HISTORIC DISTRICT COMMISSION

CERTIFICATE OF APPROPRIATENESS

Application Number: HDC2026-00106

Project Address: 264 Watson

INDICATES A WOOD WINDOW W/ SUCH EXTENSIVE DAMAGE IT CAN NOT BE REPAIRED

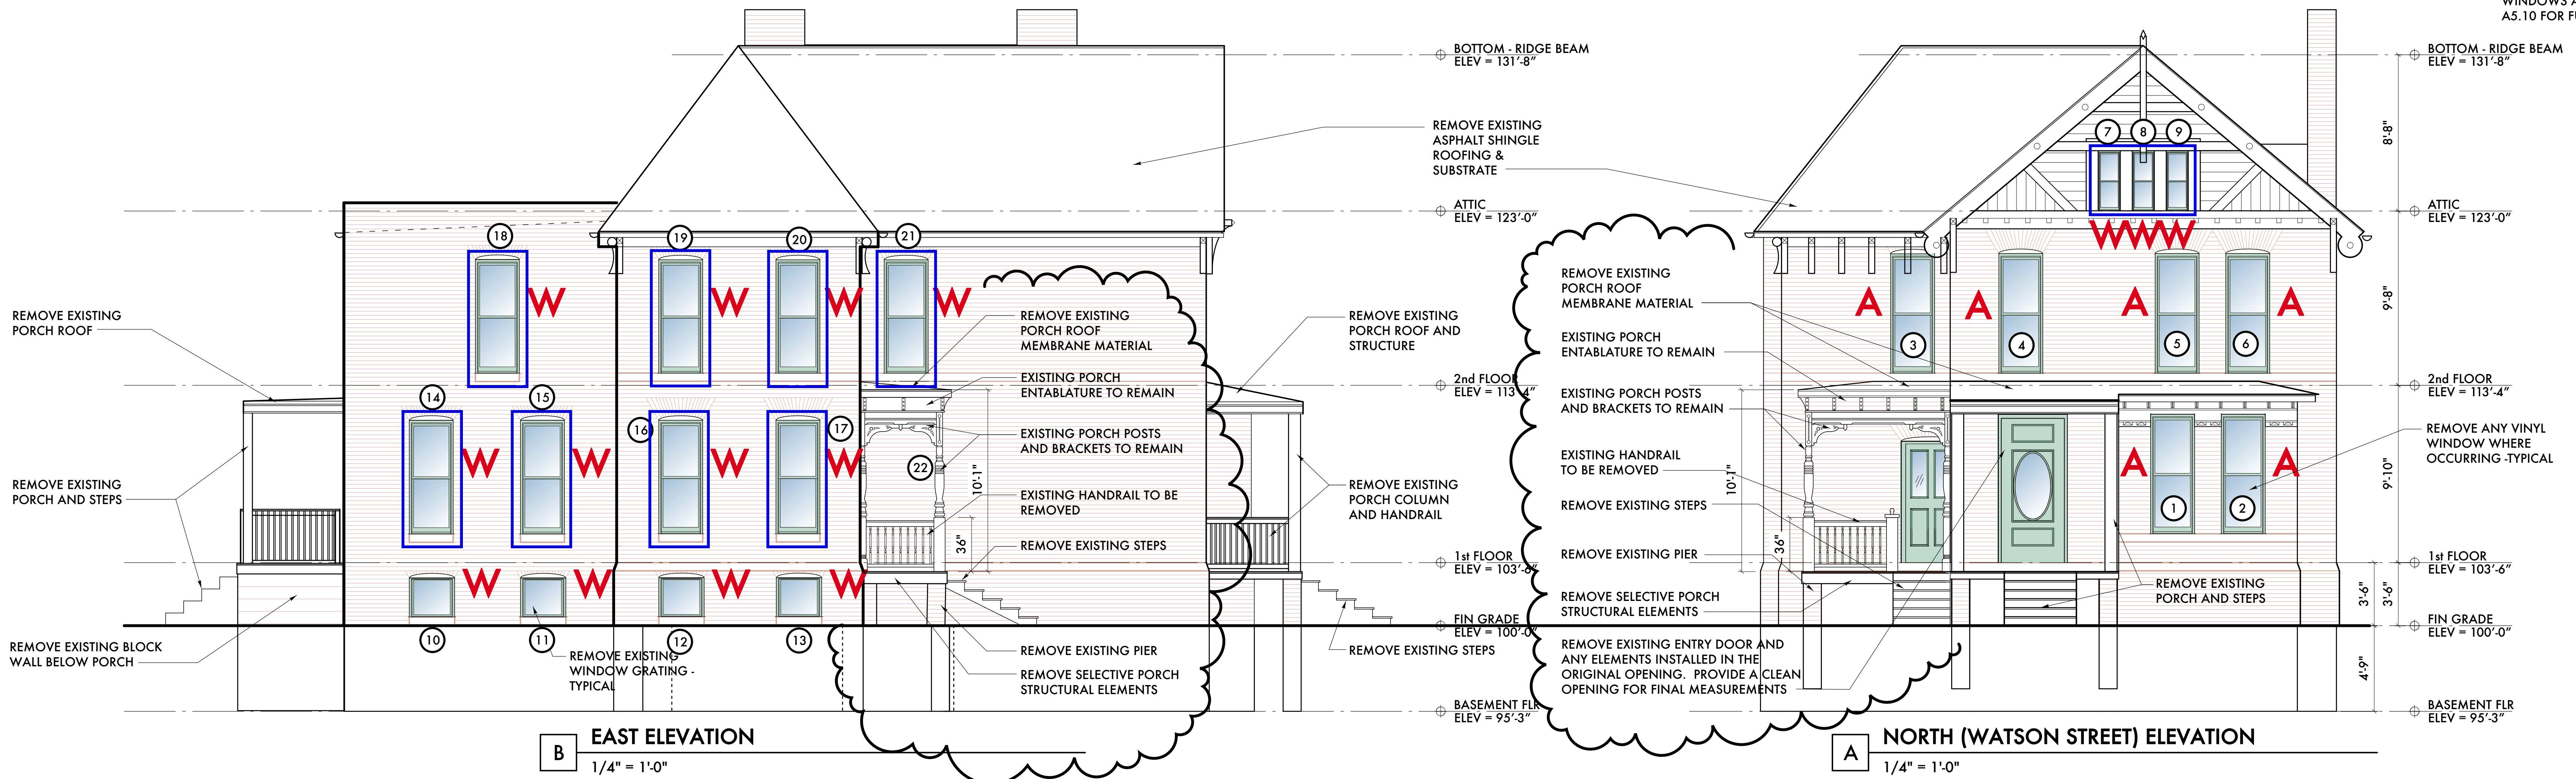
The Contractor has indicated none of the existing wood windows identified in his survey can be restored and he has provided a detailed documentation of their condition. The window proposed for the replacement of the wood windows is the Marvin Ultimate Series G2 Double Hung window which is the same window being used for the replacement of the vinyl and aluminum windows currently on the house. I have identified the particular windows on the Elevation A5.10 and updated the window Schedule A9.00 by highlighting the windows which are badly damaged.

WE HAVE HIGHLIGHTED THE WOOD WINDOWS BEING PROPOSED TO BE REPLACED WITH ALUMINUM CLAD WOOD WINDOWS

Sheet Number:
A7.62
© 2026 studioONE, llc

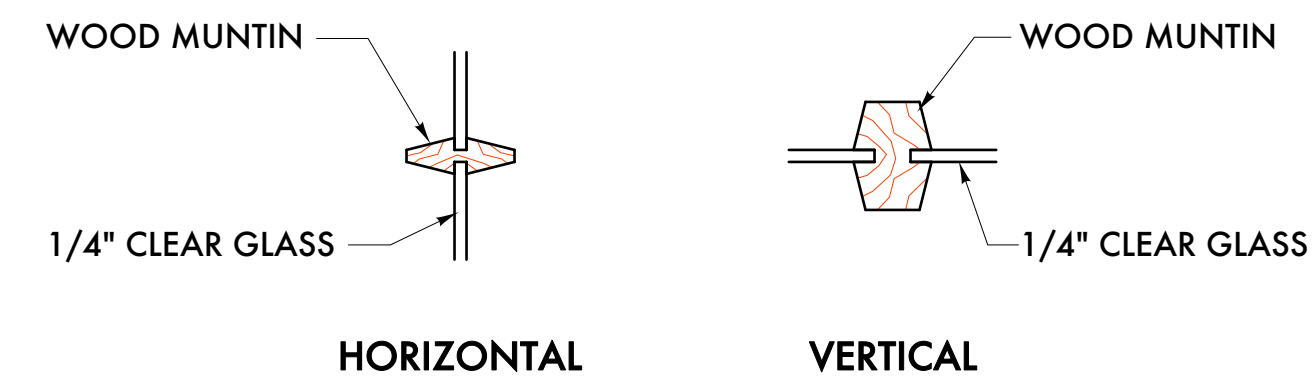
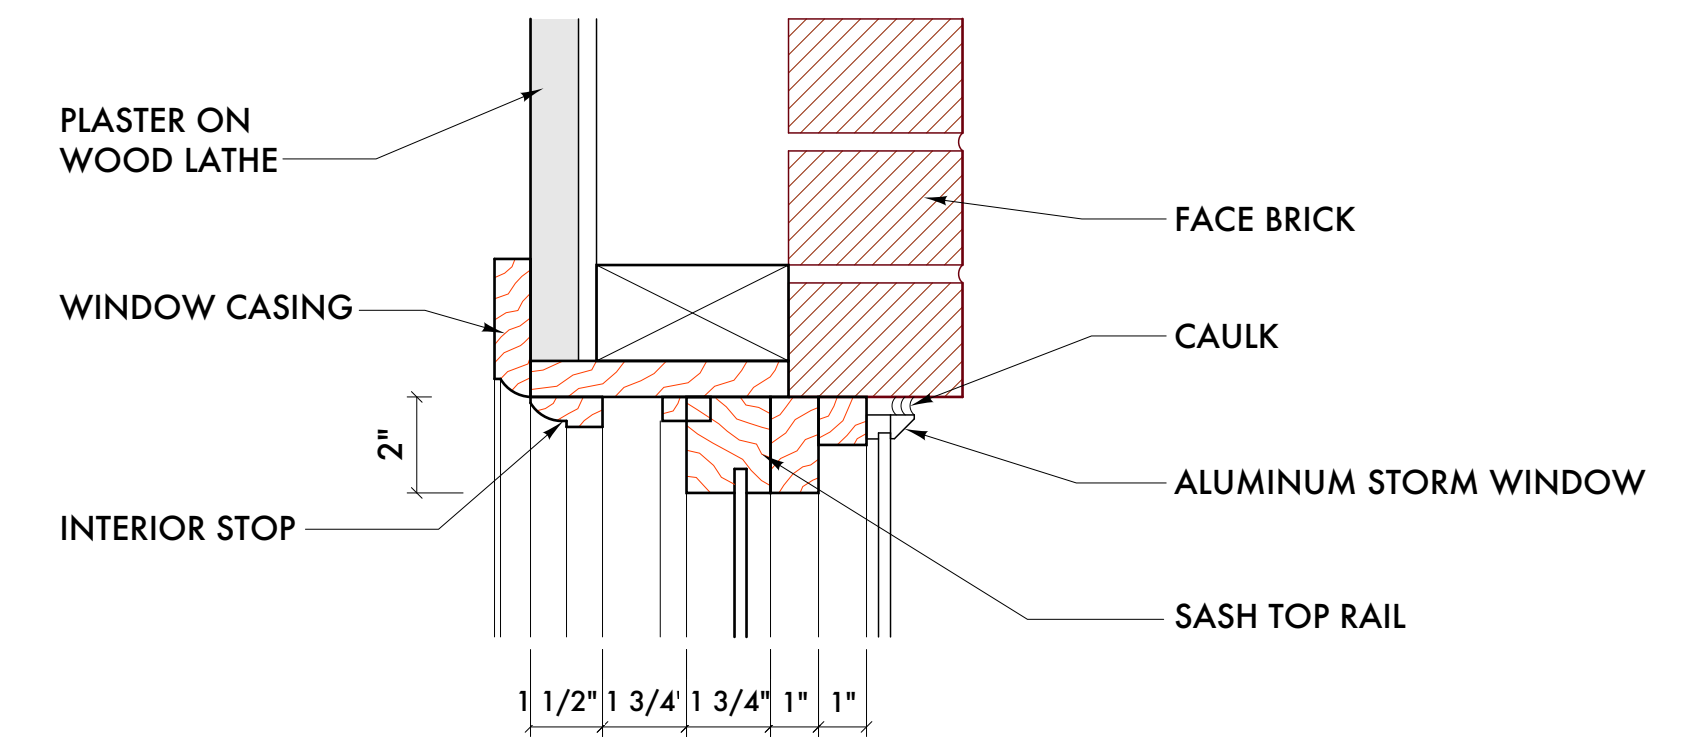
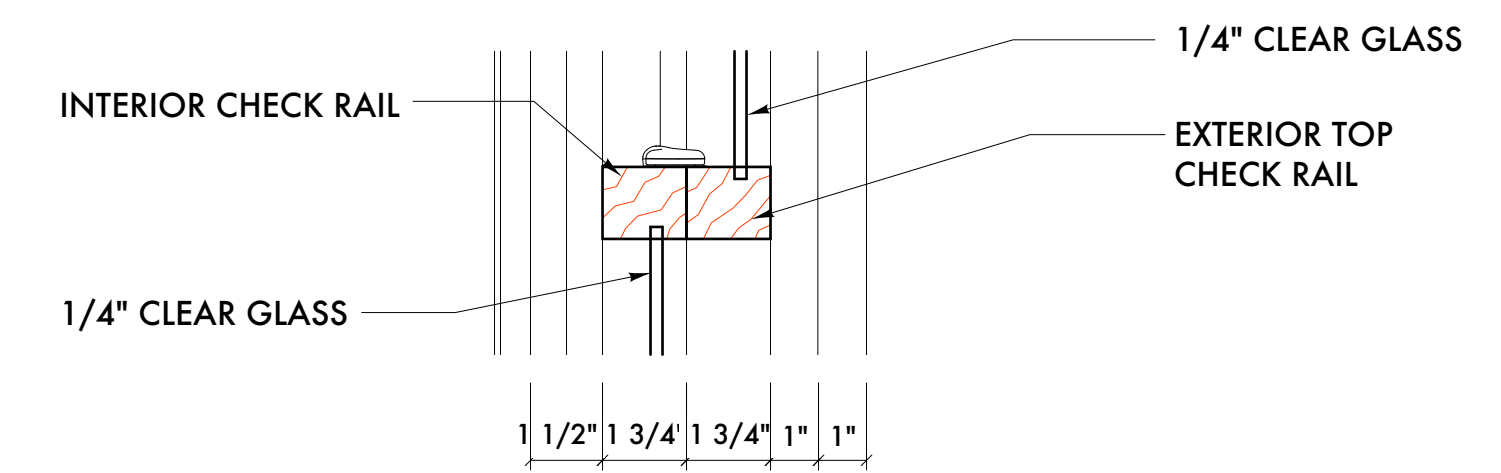
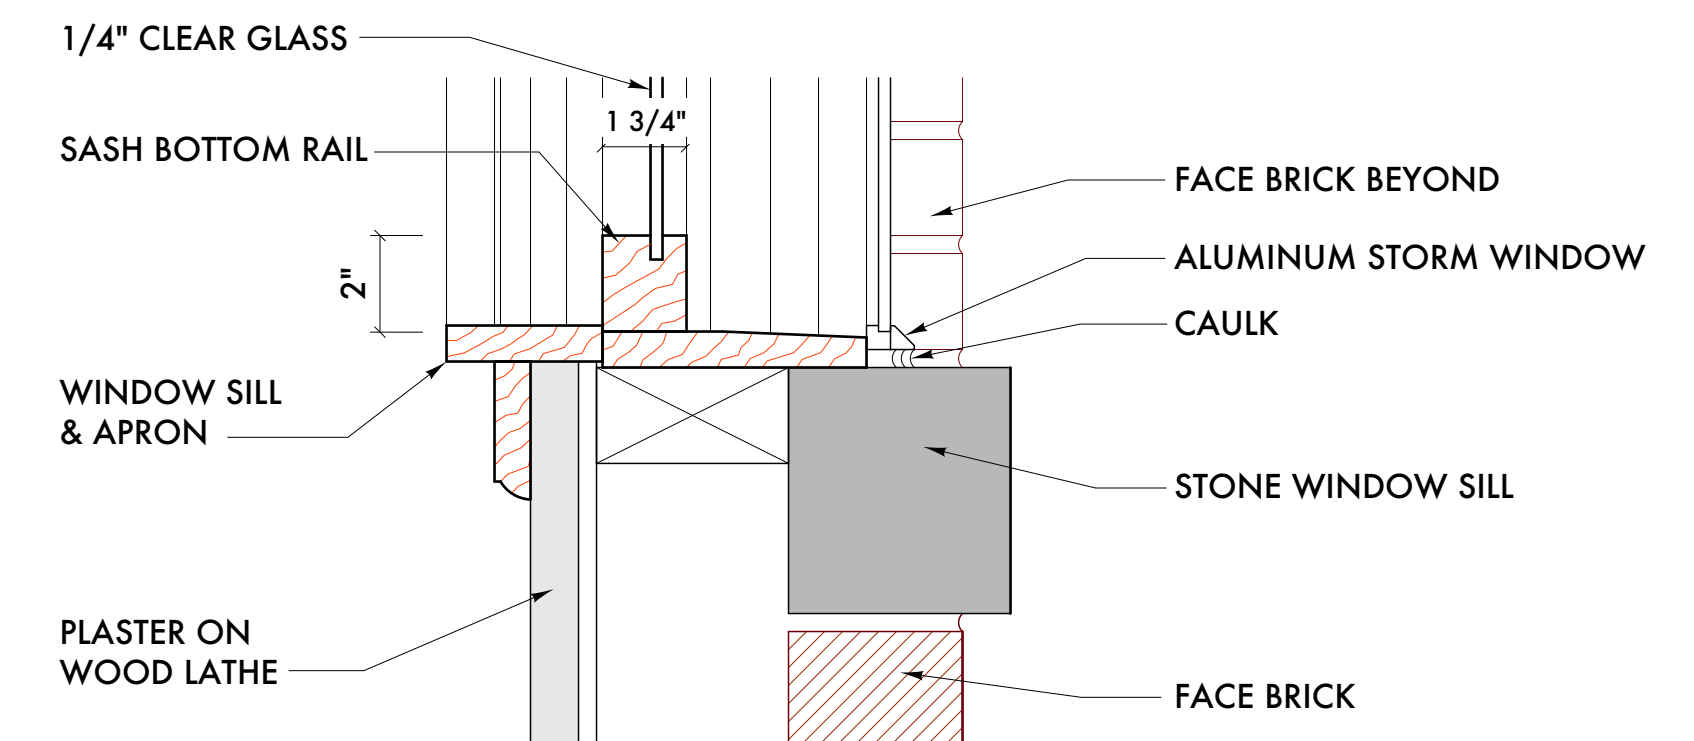
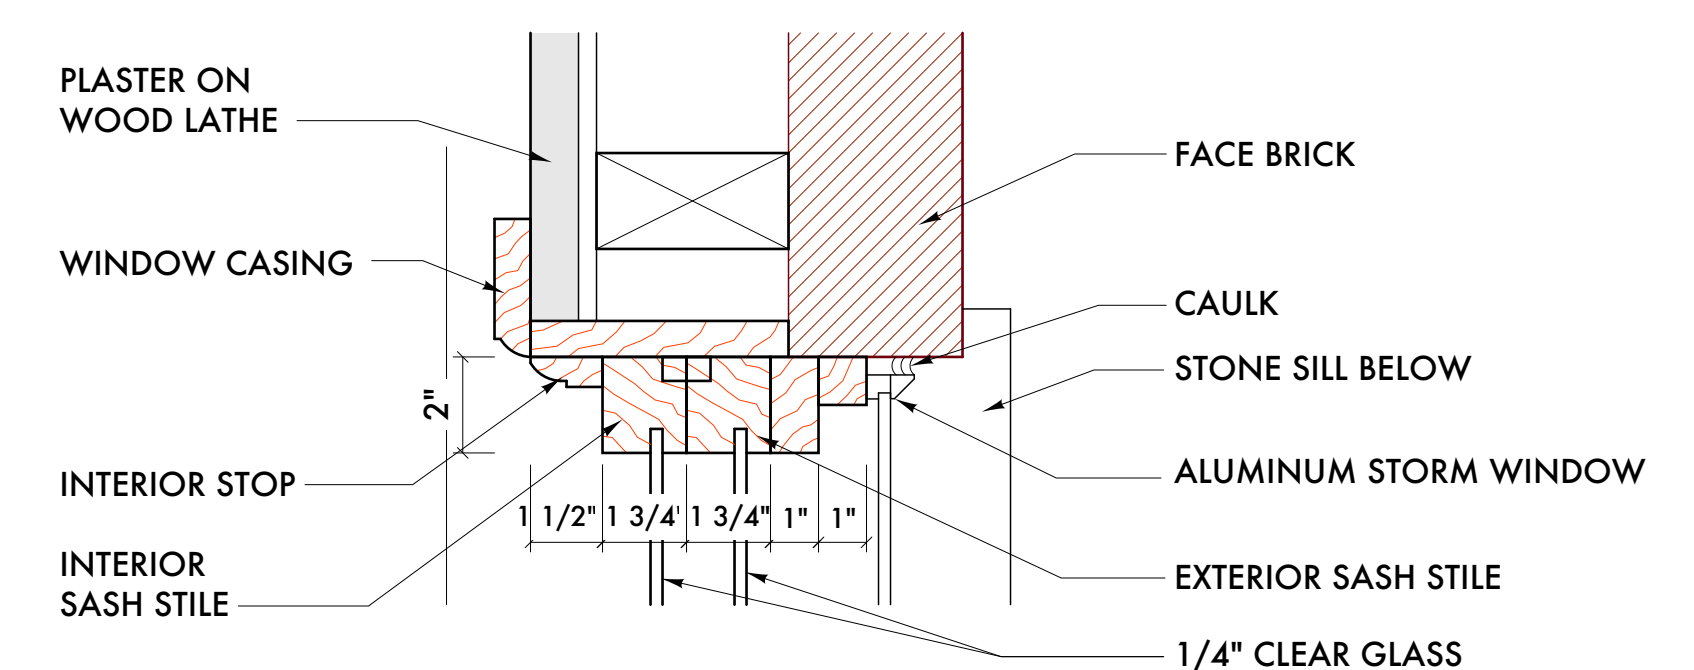
- Current photos of all 4 sides of the house from the exterior
- Exterior photos of all of the windows proposed for replacement. Each photo/window depicted in each photo must be numbered to correspond with the numbers outlined in this application's (HDC2026-00106) submitted window schedule and window condition/assessment report.
- Elevation and horizontal and vertical sections for the existing wood windows (typical). Window sections must show the profiles and typical dimensions of muntins, meeting rails, sash, frames, moldings, and other features. Also, indicate the window's relationship to the existing wall plane.

1. Drawing A500 (P) Exterior Elevation Photos is photographs of the (4) existing elevations with the existing wood windows which are deteriorated identified on the elevation.
2. Drawings A762 Ex Window Details has horizontal and vertical sectional details showing all the components of the existing windows. Additionally the page includes the proposed window details for comparison
3. The pdf 264 Existing Windows - Individual Photos has photos of each window and are identified to the numbering system found on all the elevations.
